City of Carlisle, Iowa
Planning and Zoning Commission
Regular Meeting
May 16, 2022
7:00 P.M.
City Council Chambers – 100 N. 1st Street

RE: Snap-On Warehouse – Site Plan Review
PROJECT #7023.050

FOX Strand has completed the second review for the Snap-On Warehouse Site Plan dated May 12, 2022 and have the following comments:

REFERENCE NUMBER:	
DRAWN BY:	GSA
CHECKED BY:	SVS
REVISION DATE:	1ST CITY SUB 2022-04-28
PROJECT NUMBER:	220102
SHEET NUMBER:	C2.1

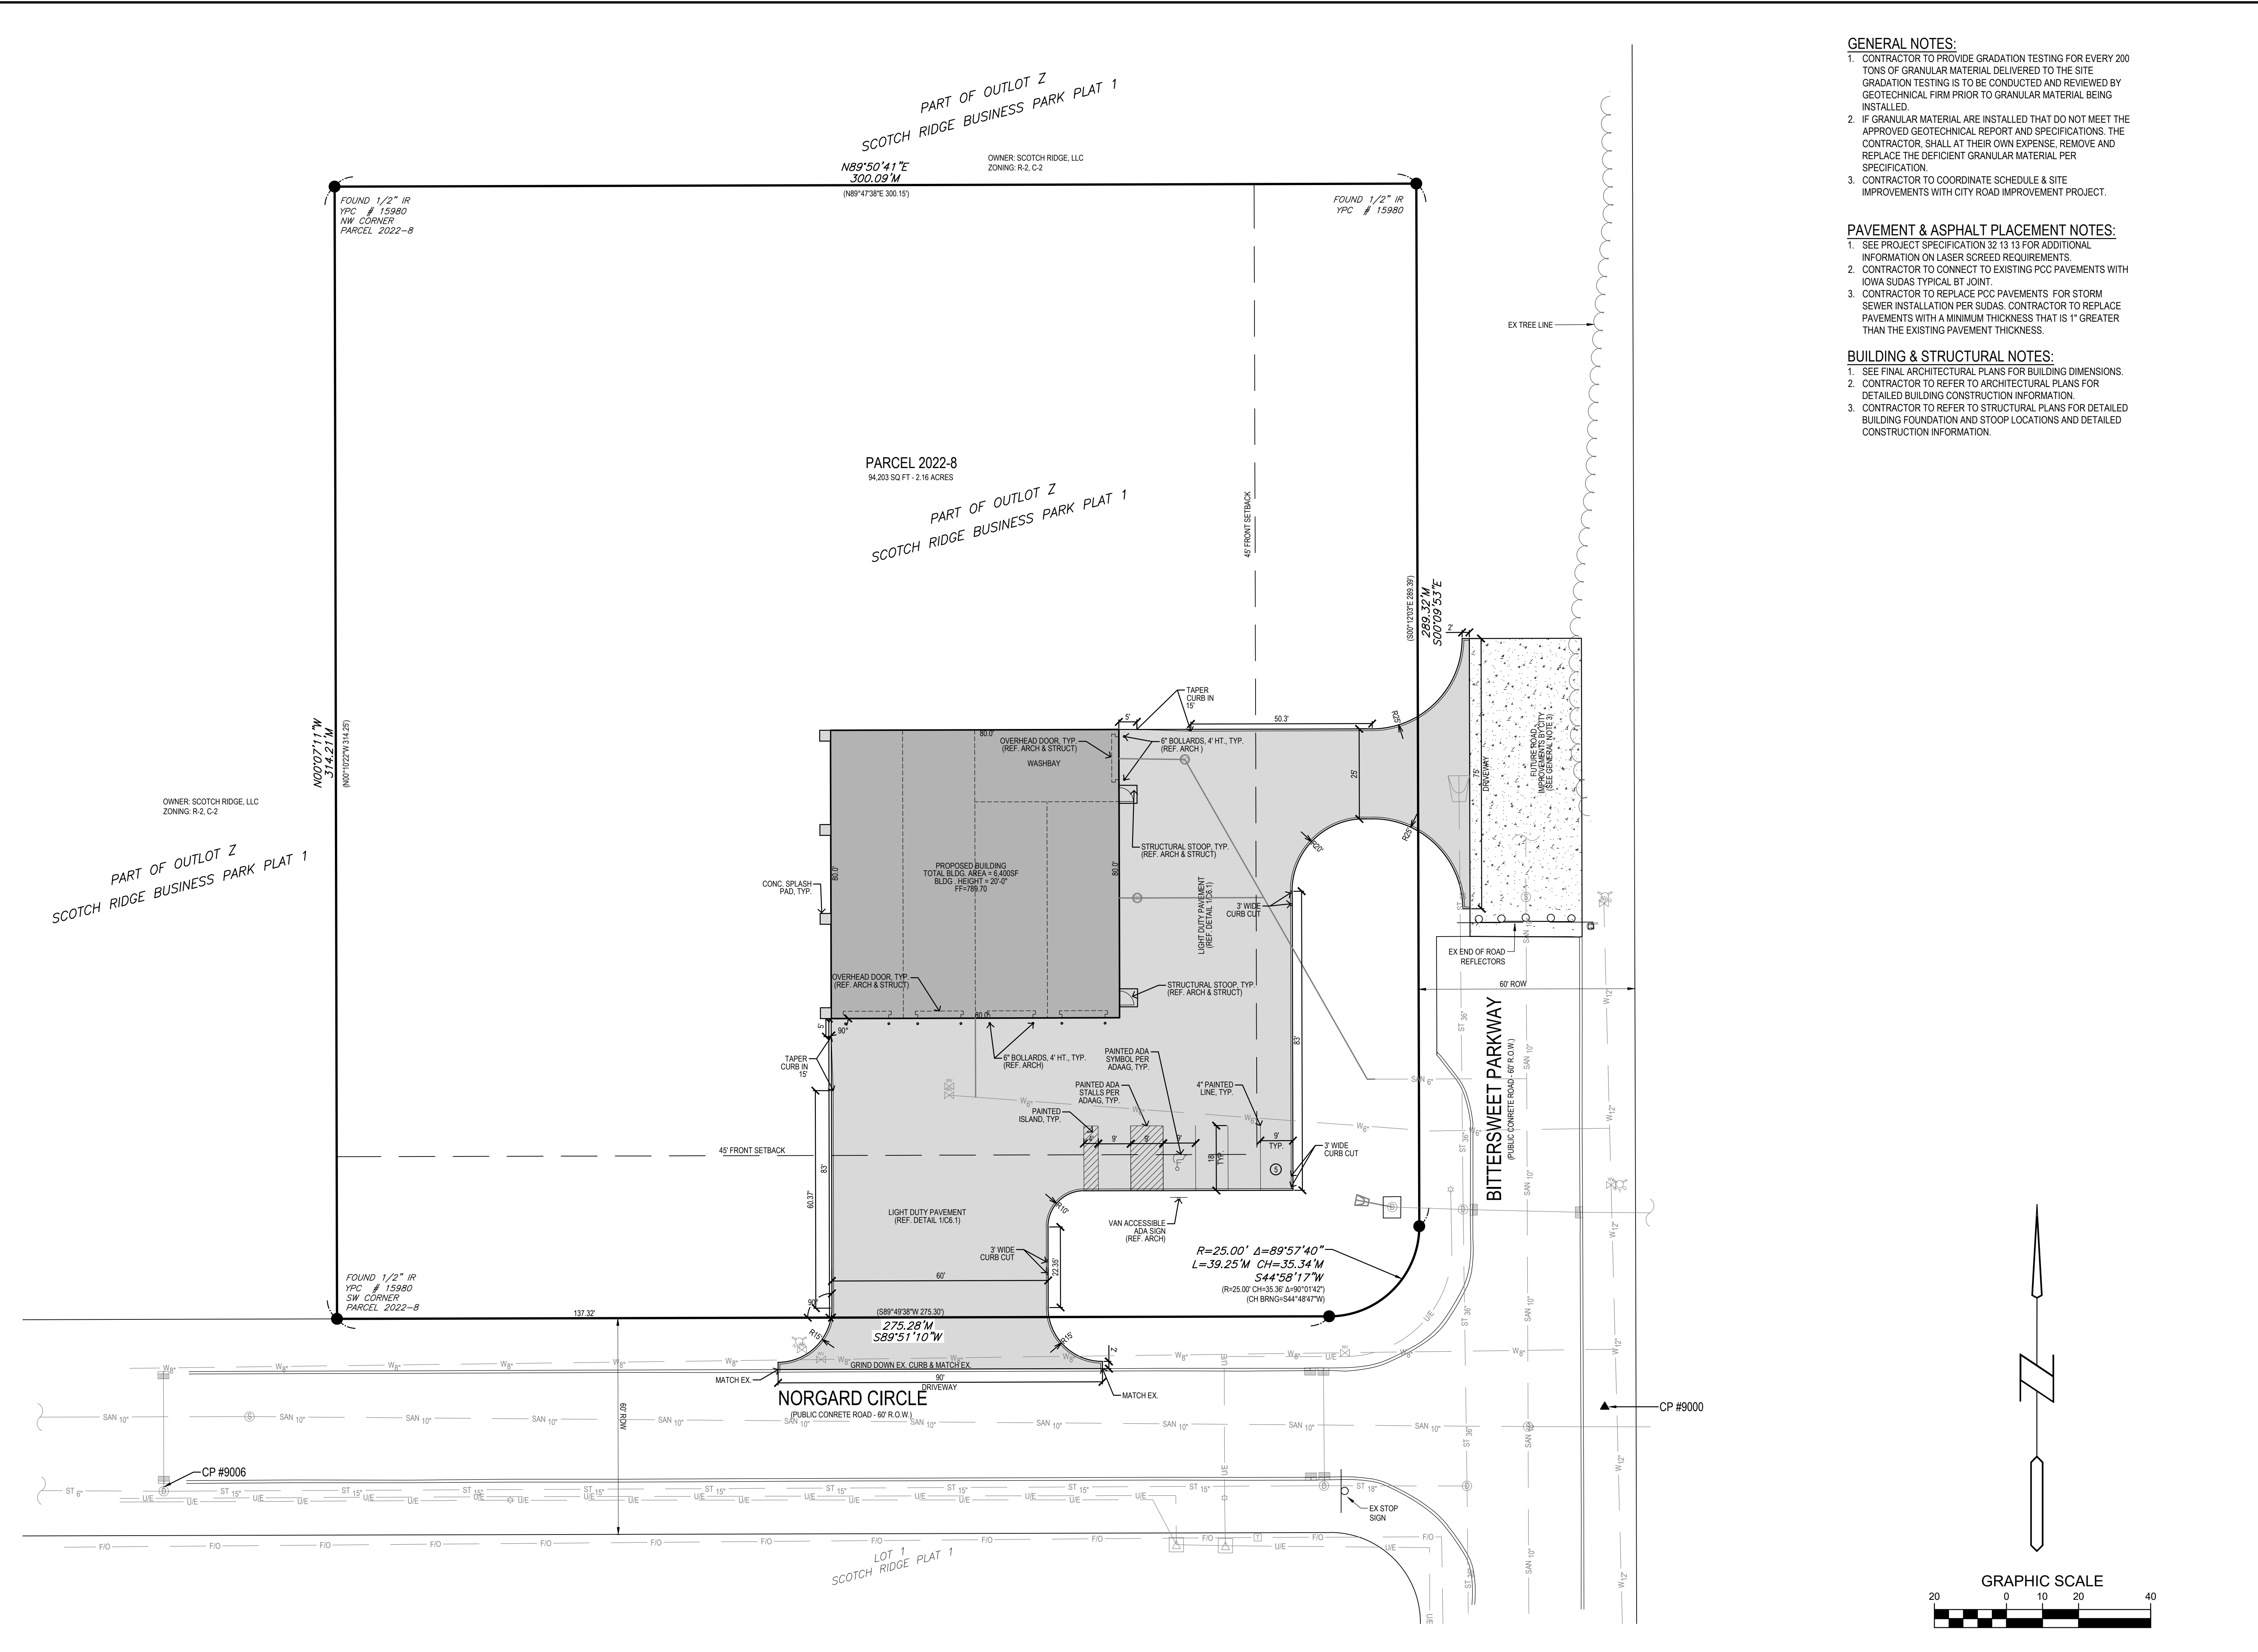
9. Please clarify the type of all proposed outdoor lighting including wallpacks. Please verify it meets 165.06, 5, I of the Carlisle Code. Please verify pole height and that the fixtures are sharp cutoff.

REFERENCE NUMBER:	
DRAWN BY:	GSA
CHECKED BY:	SVS
REVISION DATE:	1ST CITY SUB 2022-04-28
PROJECT NUMBER:	220102
SHEET NUMBER:	C3.1

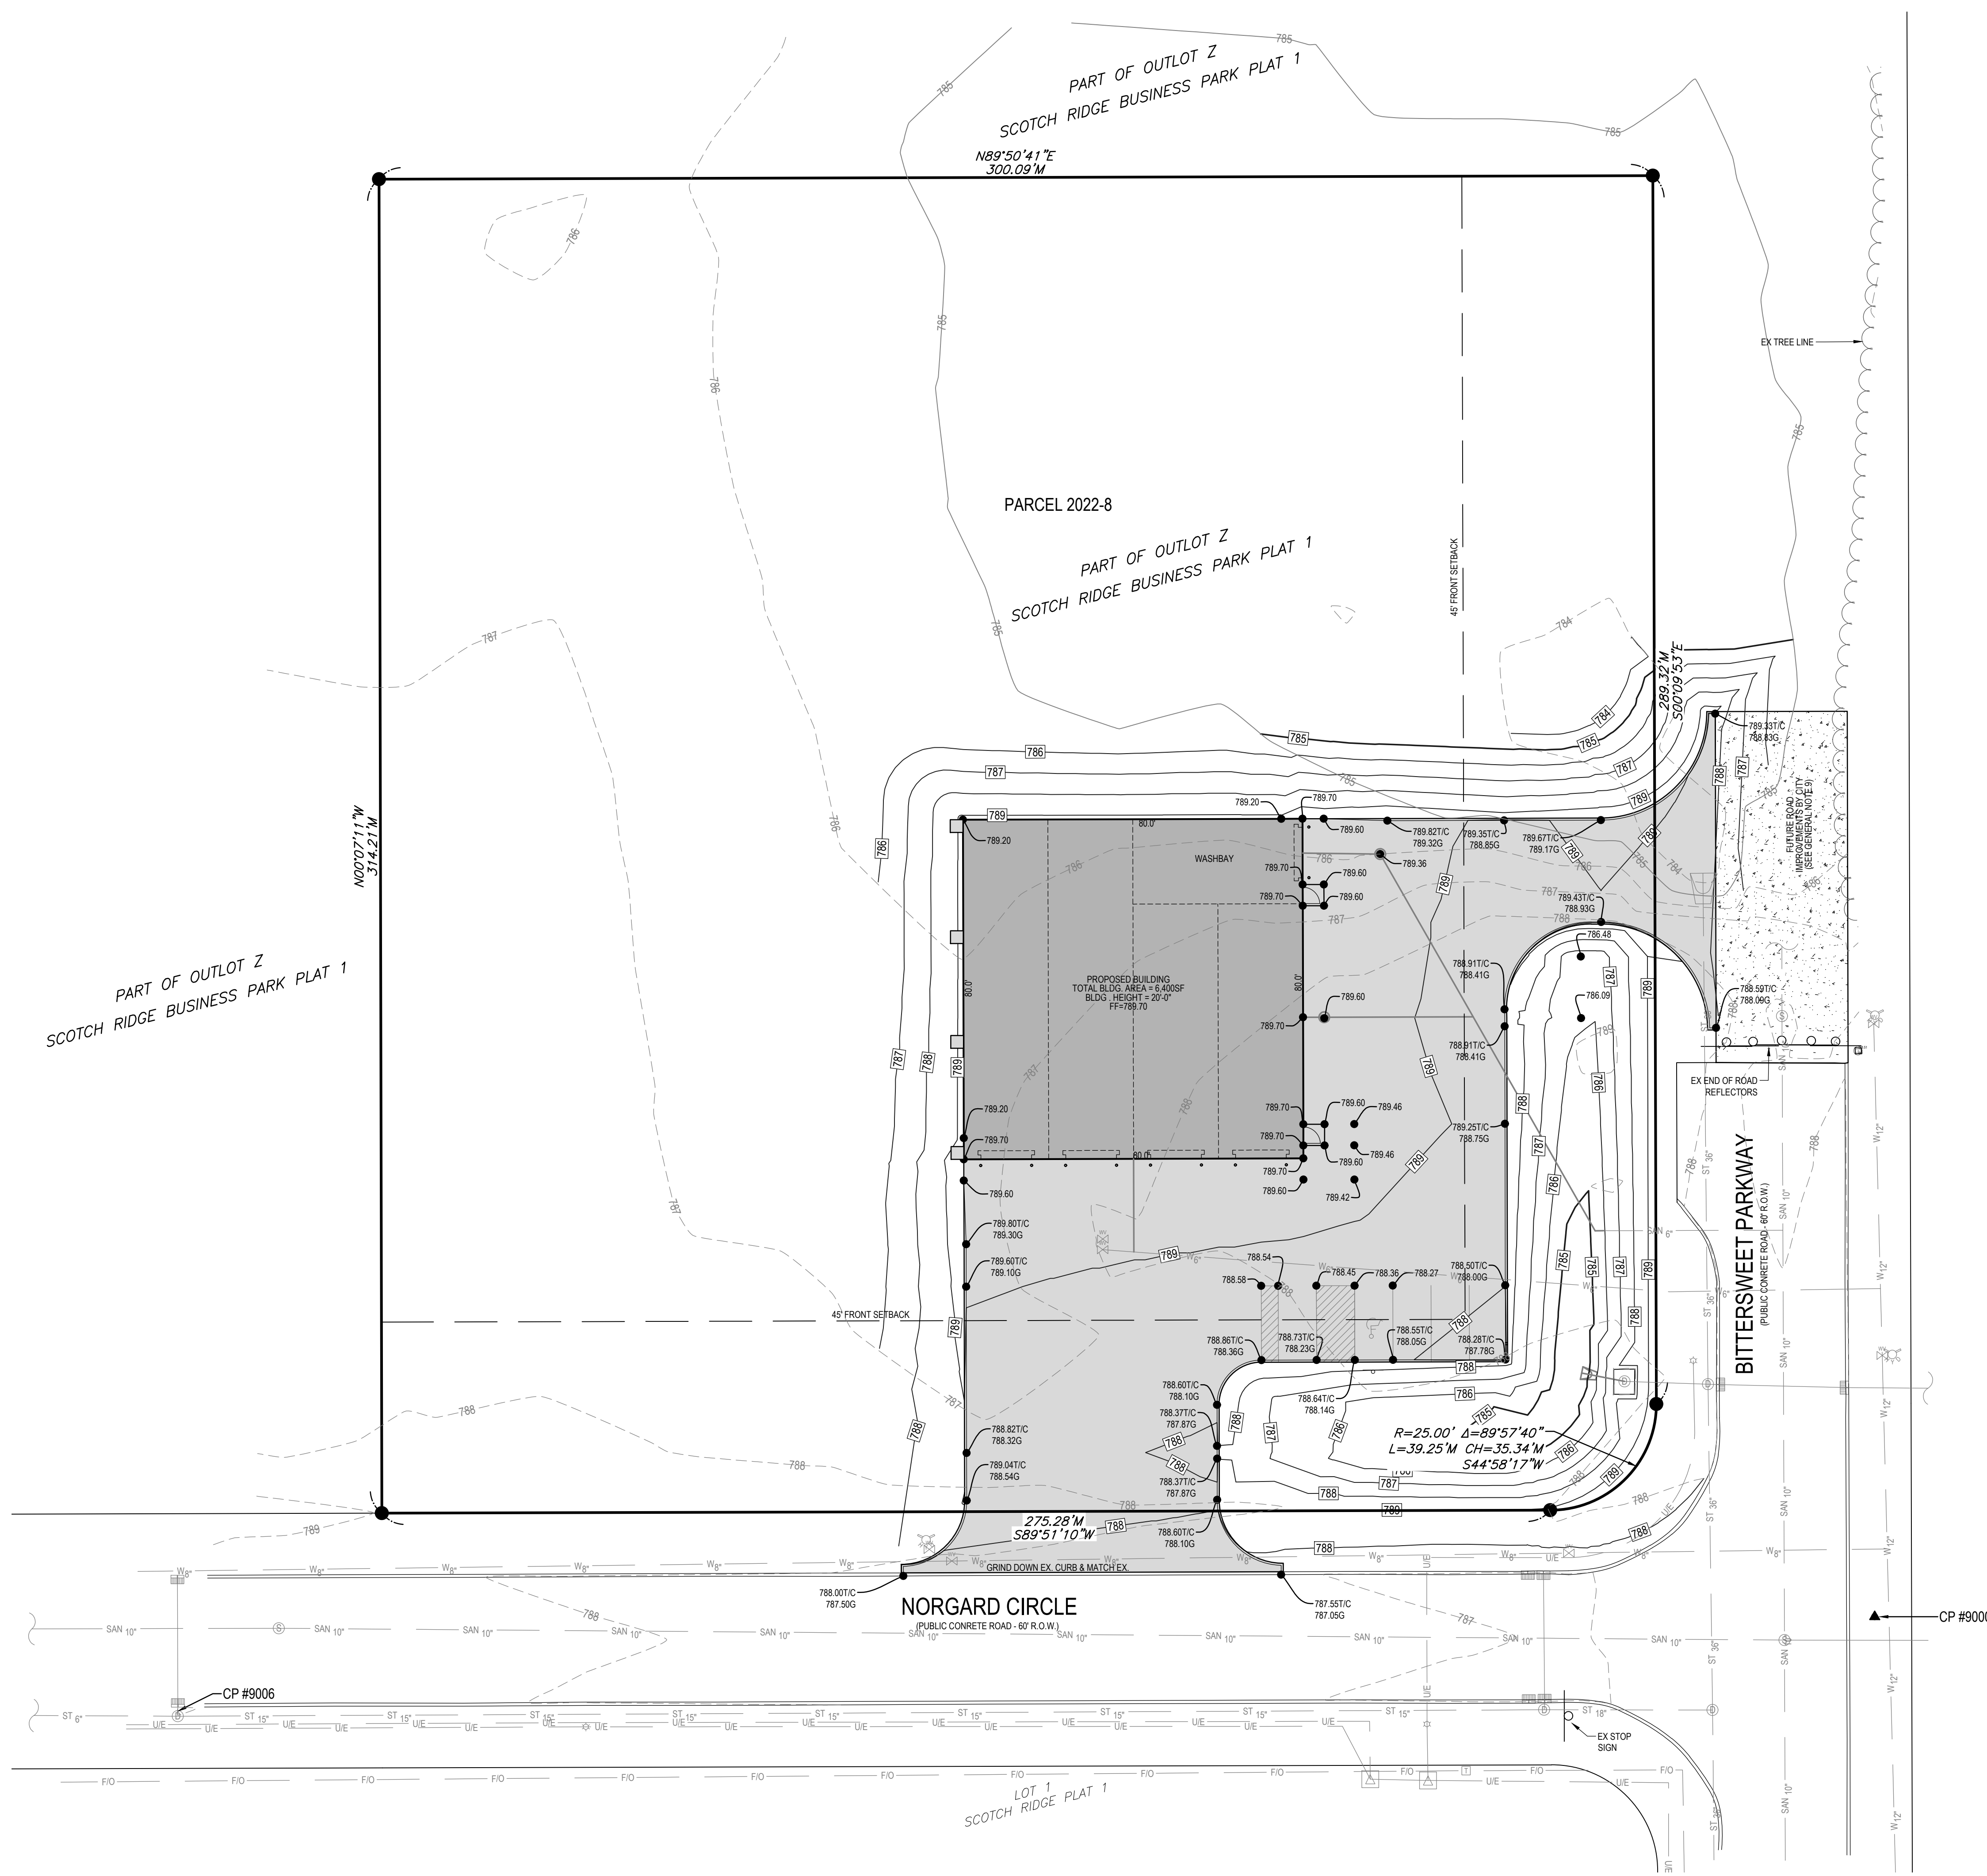
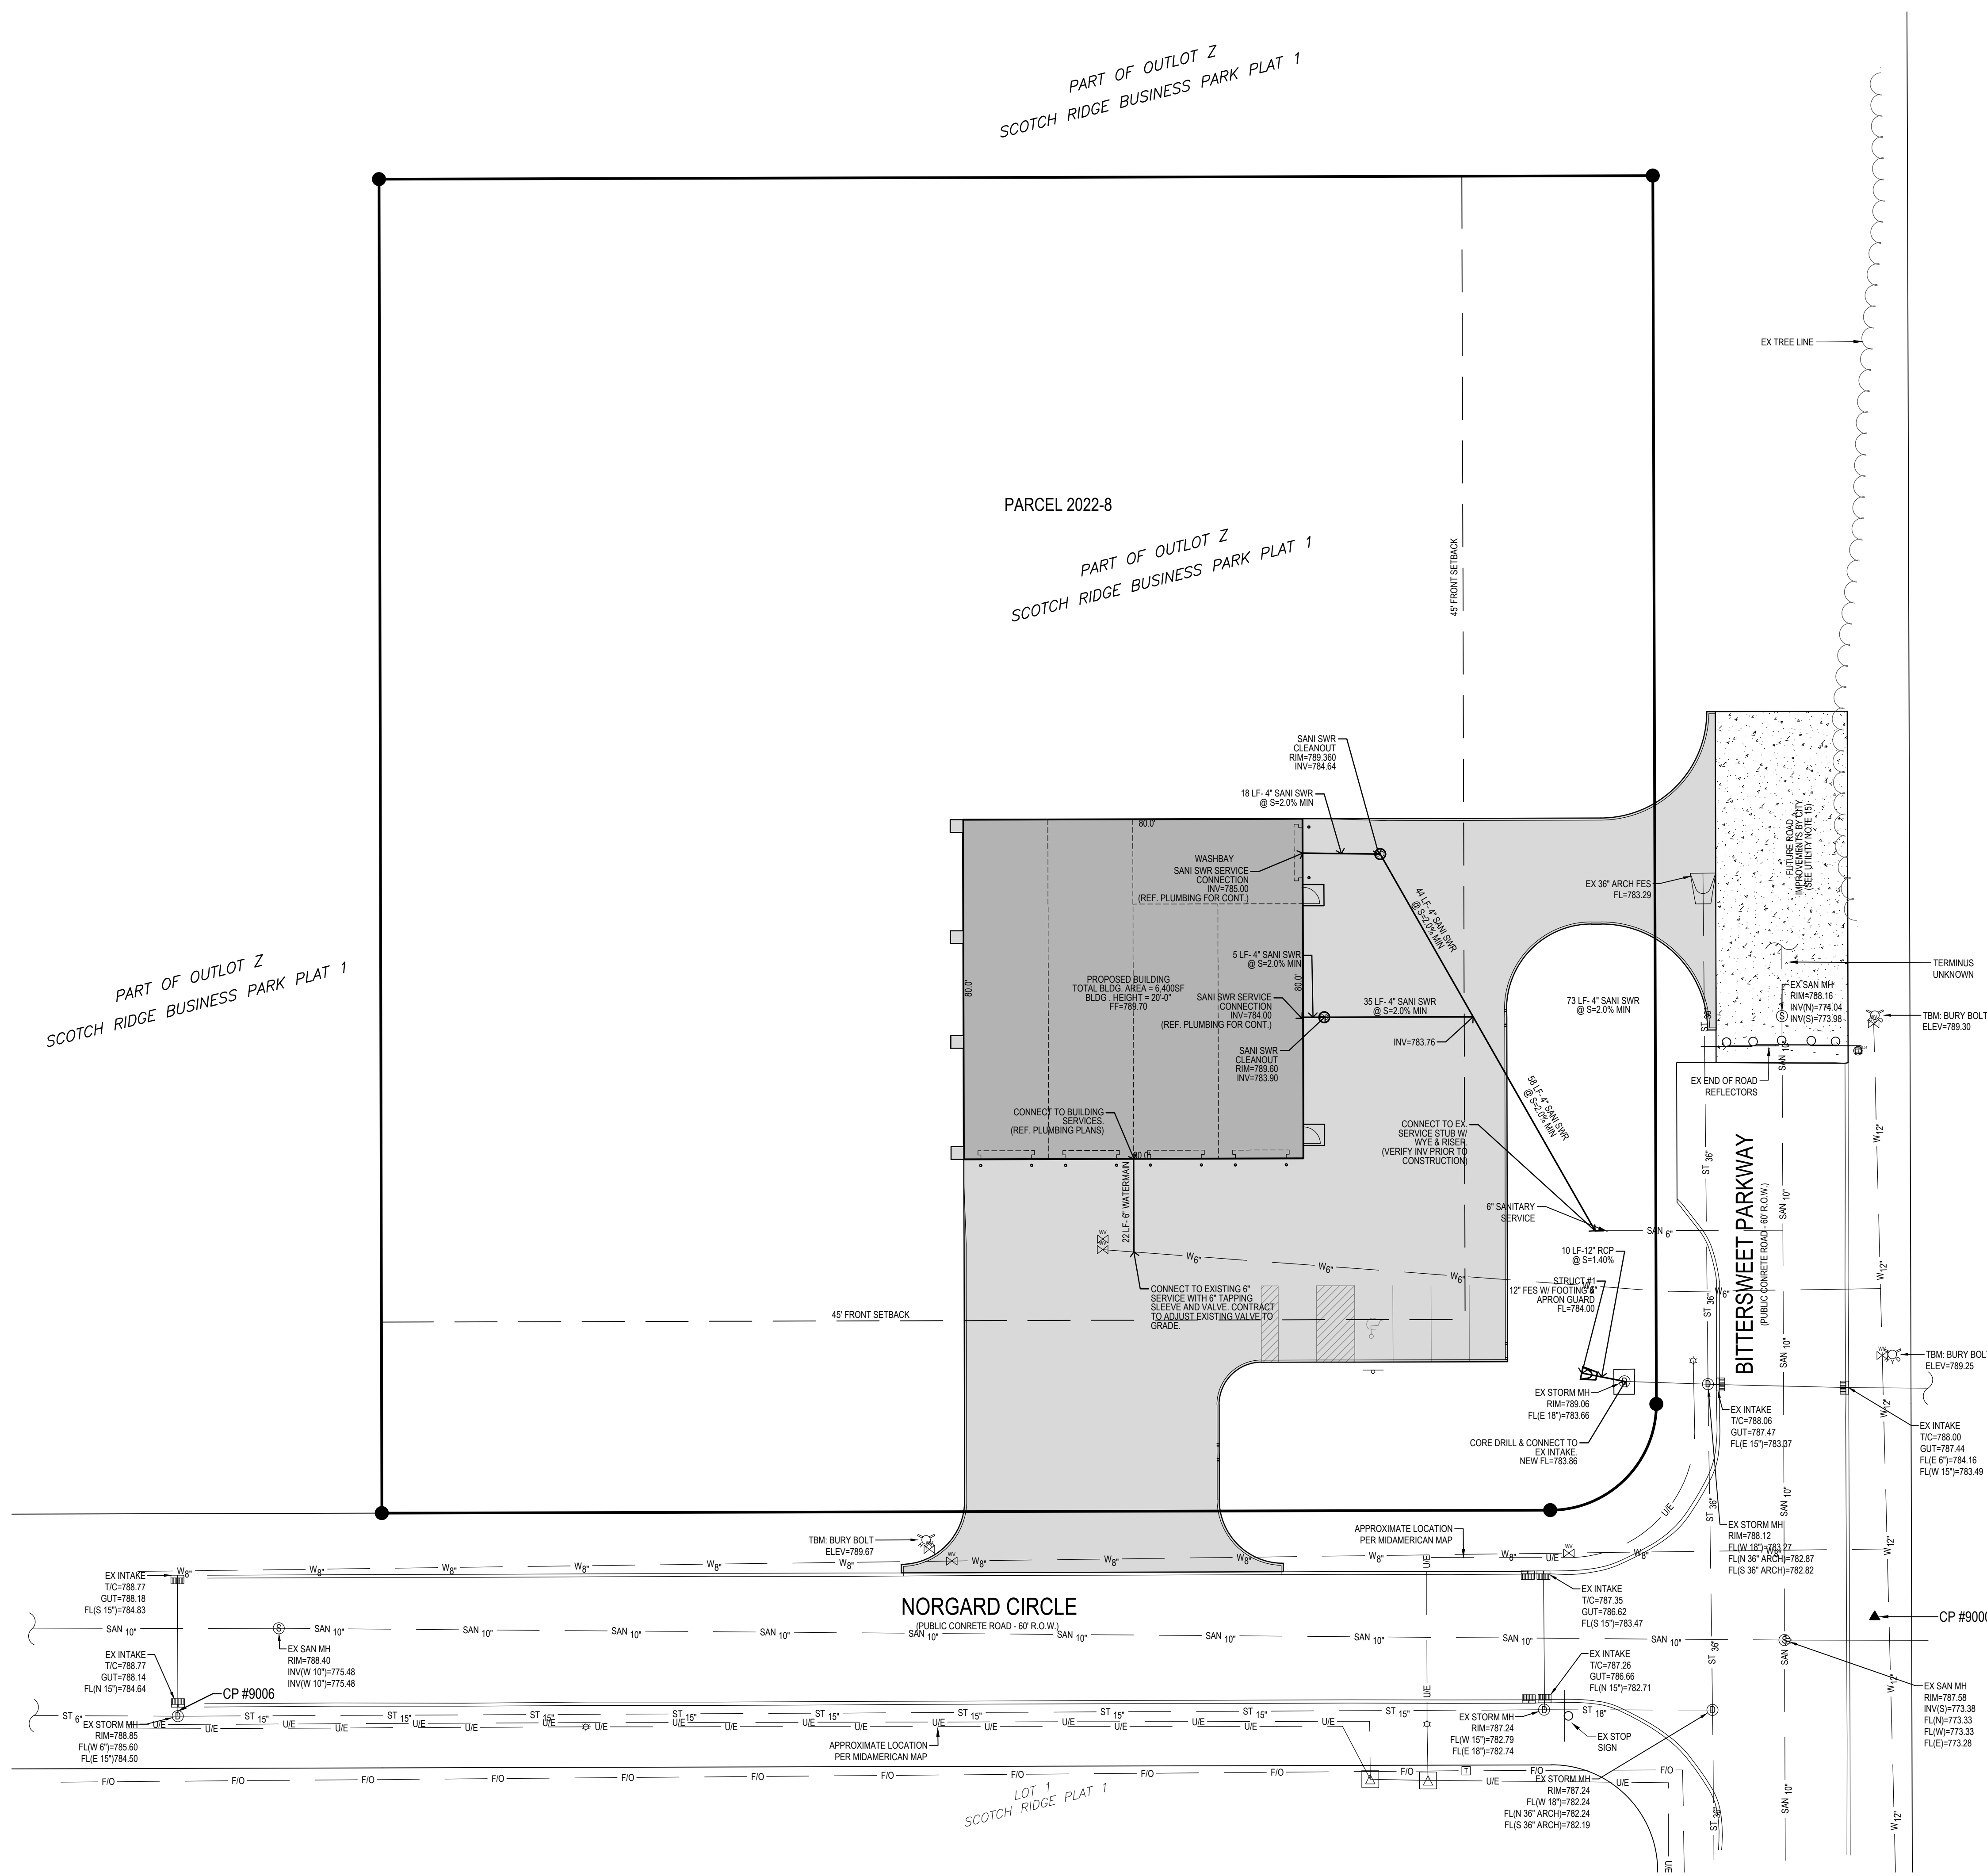
10. Is there supposed to be a curb cut at the 787.87 G label near the southern entrance? Please label and provide erosion control.
11. How will the 784 contour in the NE corner of the parking area drain? This may require some coordination with Erin O. at CDA as CDA is responsible for the roadway CDs. Please show the new intake that is described on sheet C3.1.

12. Please label the overflow elevations in the outlet structure.
